Zoning & Subdivision Committee

Thursday, December 13, 2018

Staff Report – Glacier Park Neighborhood Section 11

PRELIMINARY PLAT PLANS FOR JEROME VILLAGE GLACIER PARK NEIGHBORHOOD, SECTION 11

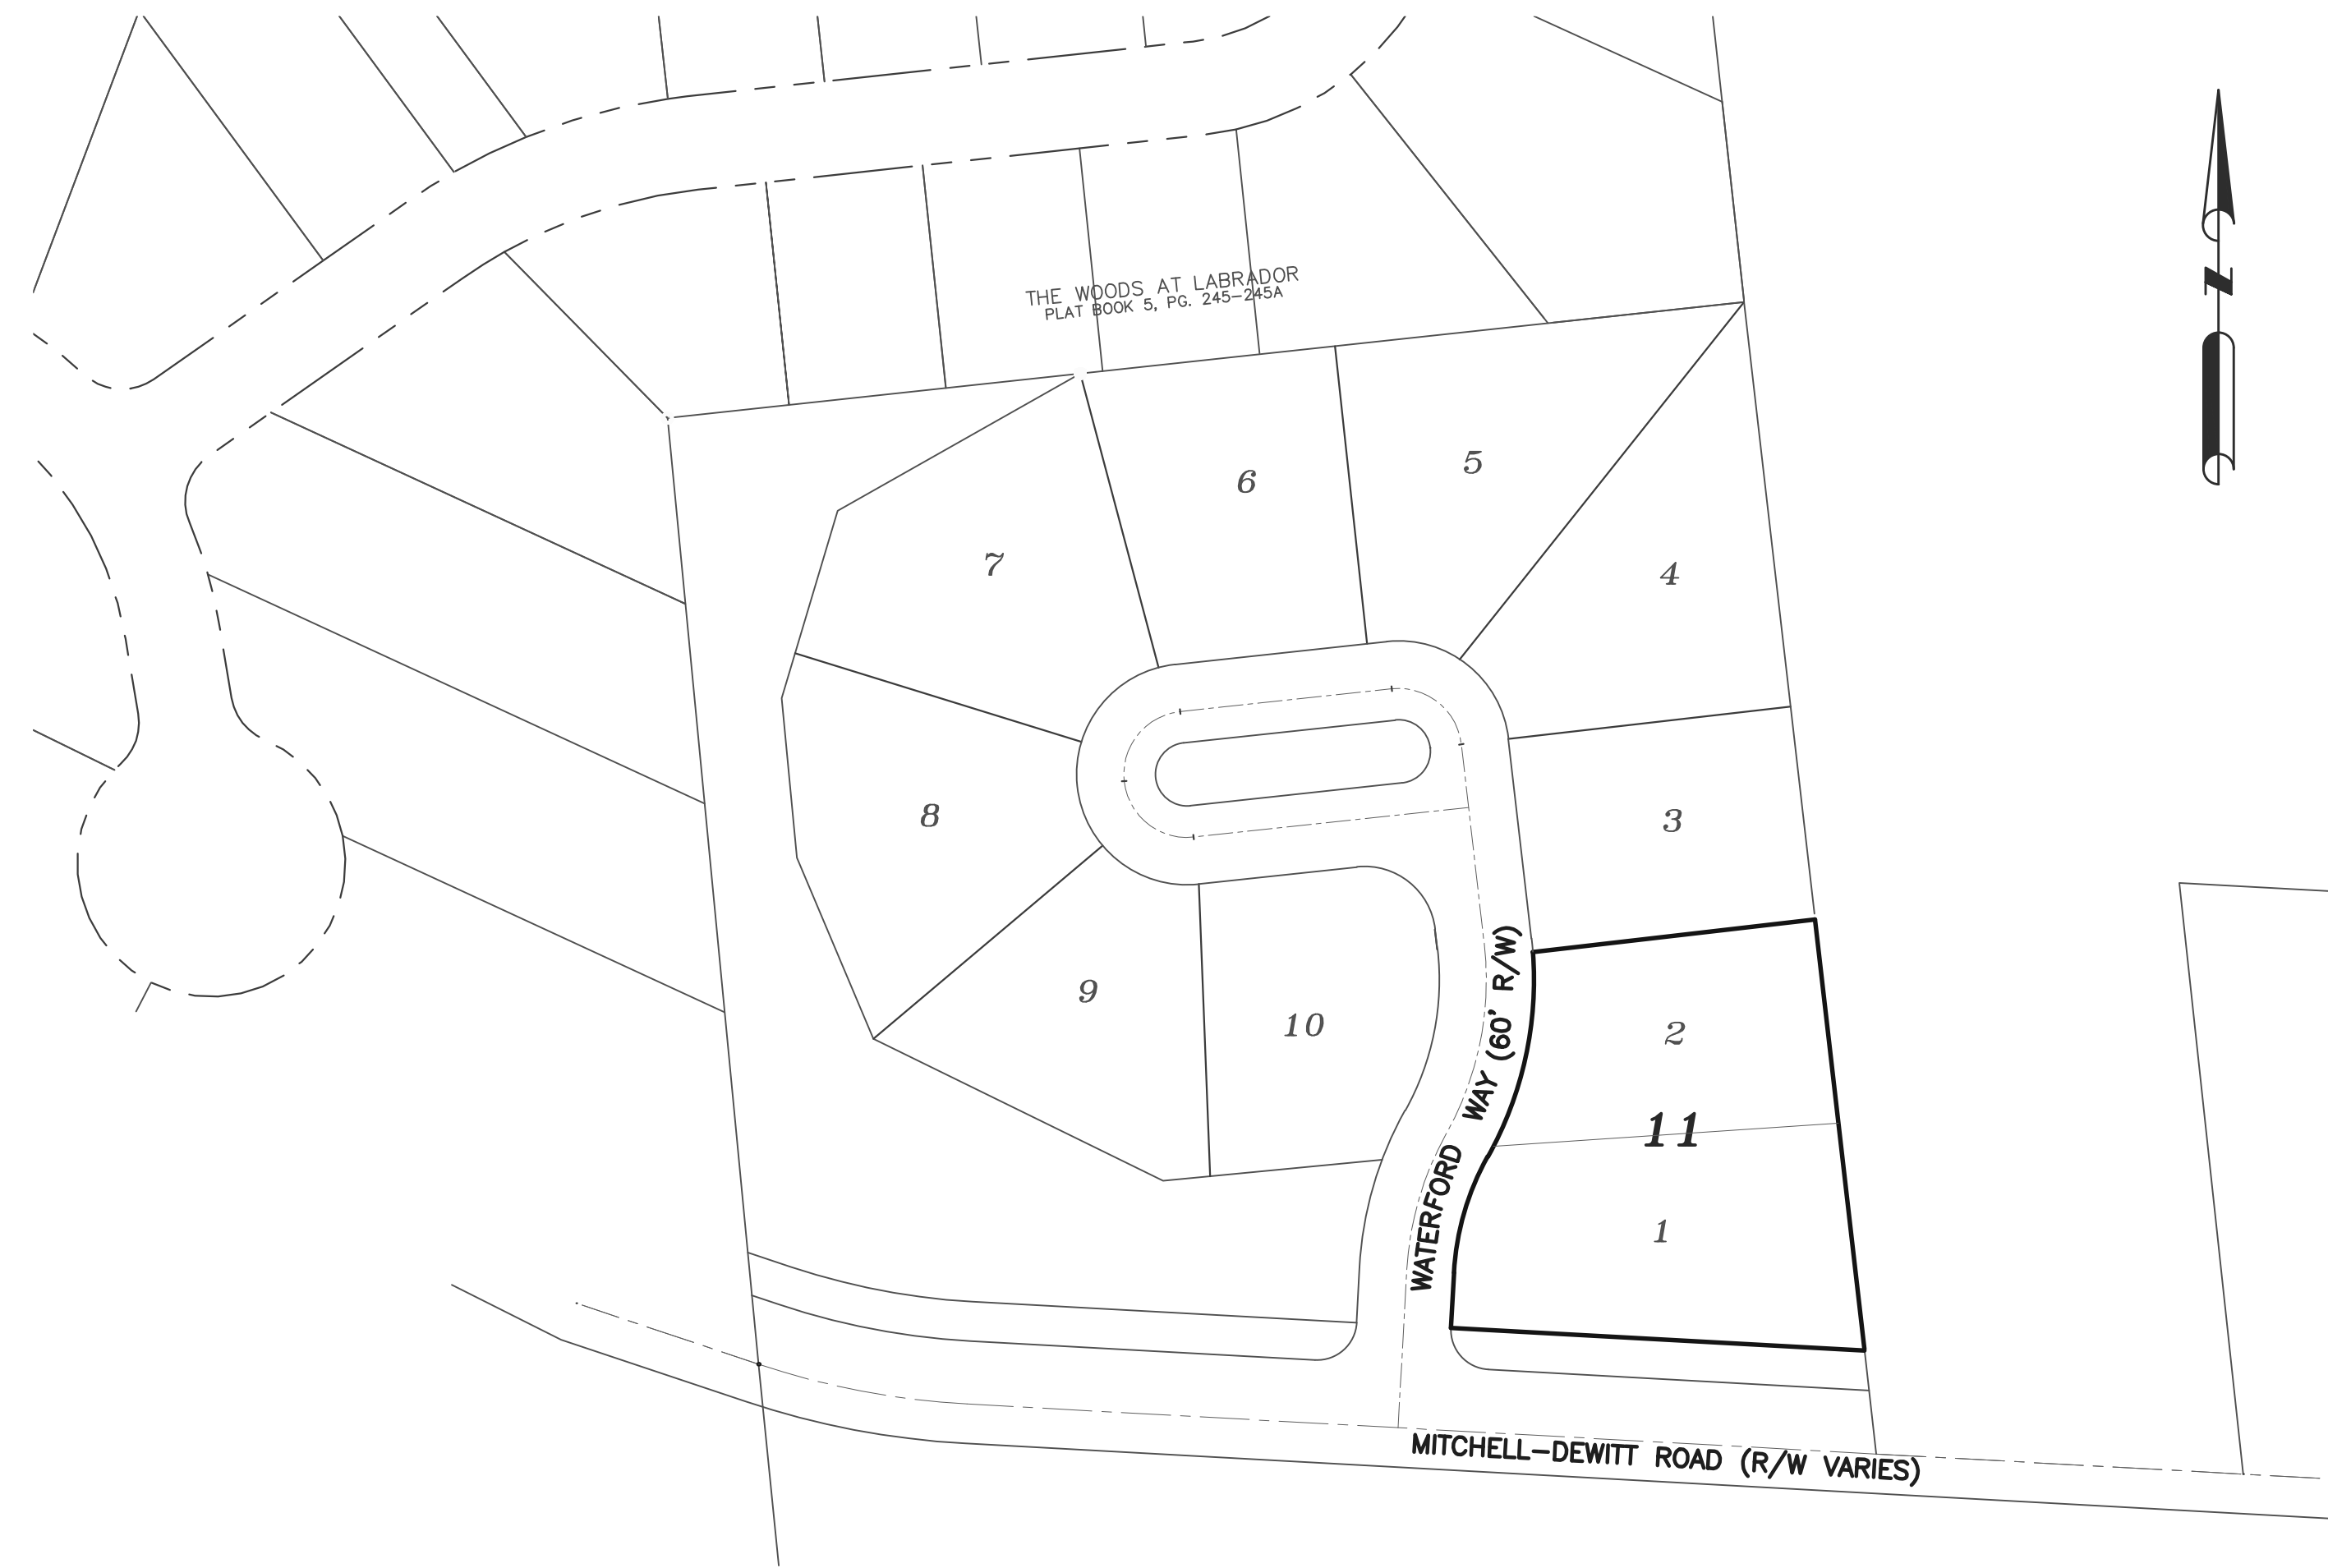
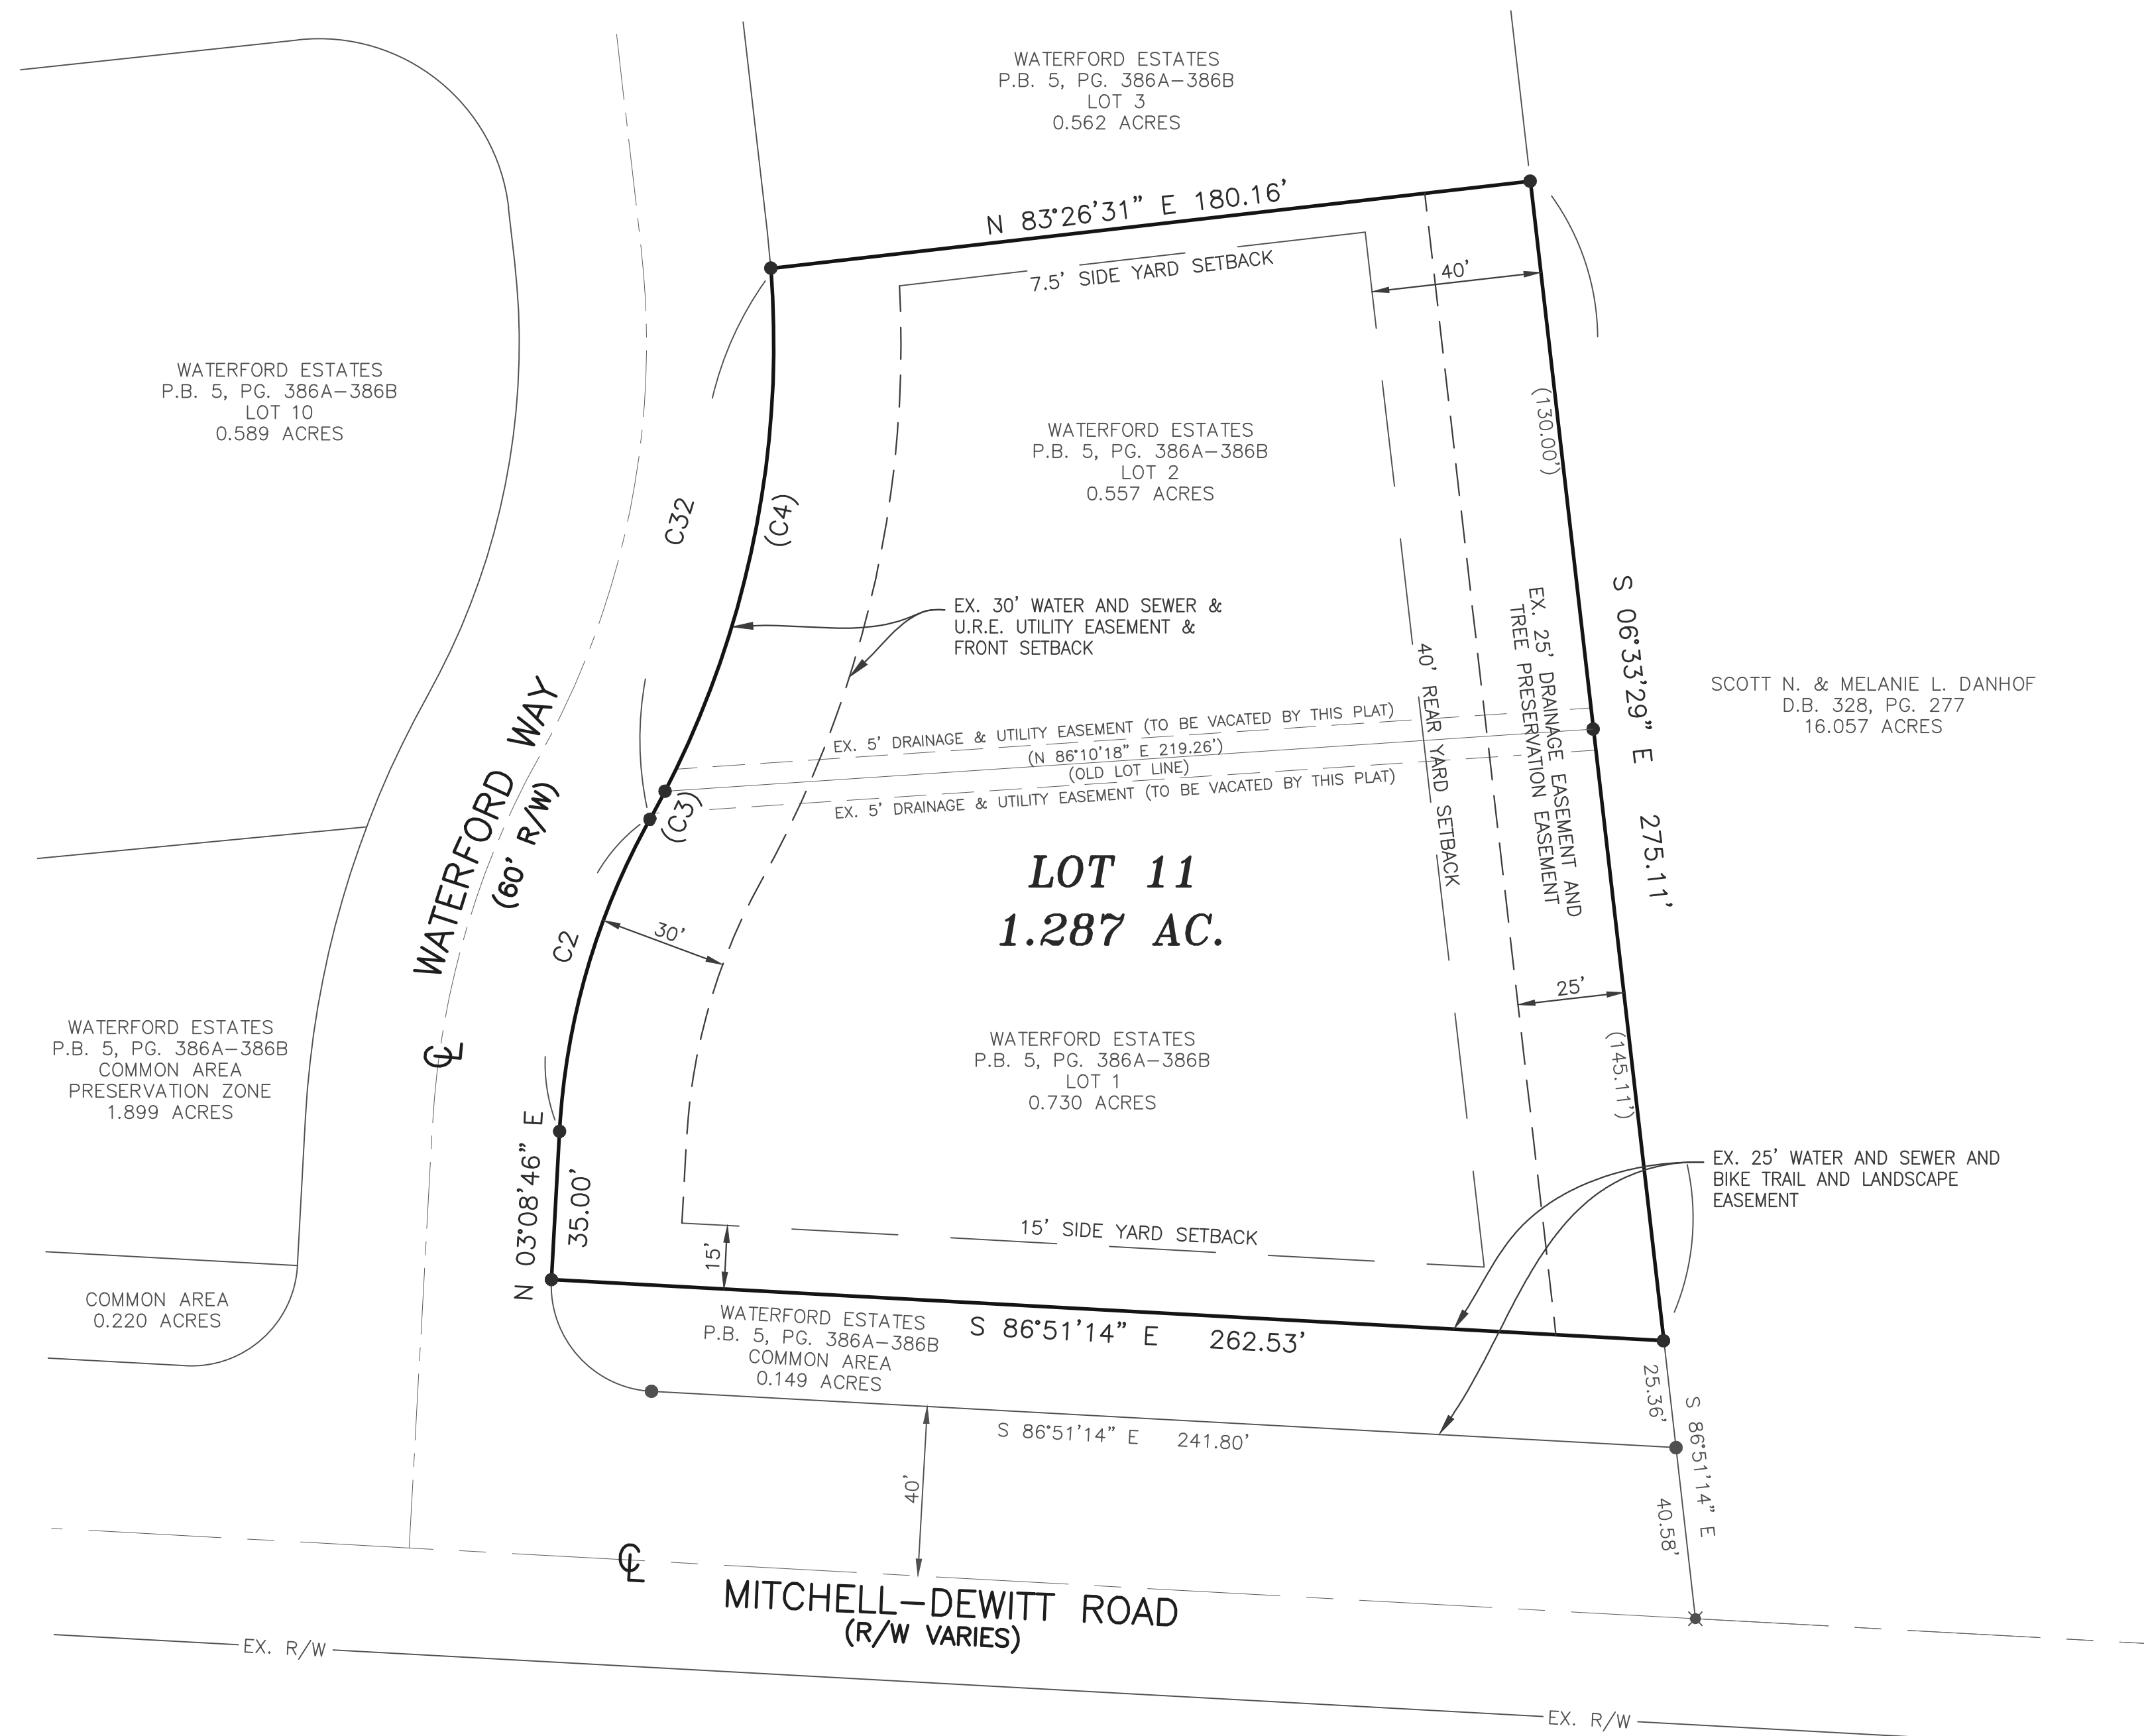
- Comments from the Engineer's Office are below:
 1. Sheet 1: Provide the recording information for the covenants, restrictions, and easements.
 2. Sheet 1: The amended lot should be numbered as one of the existing lots that comprises the combined lots. Preference is to label it as Lot 2, as that is the lot number that contains the residential structure.

3. Sheet 1: Records indicate the owner of Lot 1 is Clemens Development Company. As such, they are required to be a signatory on the plat.
 4. Sheet 1: The proper instrument number conveying Lot 2 to the Stamps is 201805140003650. As mentioned, Lot 1 is not owned by the Stamps and shall have the proper instrument number included in the description section.

5. Sheet 1: The existing map numbers shown in the description section shall have “.000” added at the end of the map number.
 6. Sheet 1: Revise the right-of-way dedication note to read, “Rights-of-way for public streets and roads herein dedicated to public use were approved on the 19th day of July 2016, per Plat Book 5, Pages 386 A&B for the County of Ohio State of Ohio.” The remainder of the statement can stay the same.

7. Sheet 2: Revise the lot number per comment #2.
 8. Sheet 2: No drainage/utility easement exists per the previous plat or based on our research between existing Lot 1 and Lot 2. If such an easement does exist, please indicate the recording information that created said easement. Otherwise, remove indication of this easement from the plat.
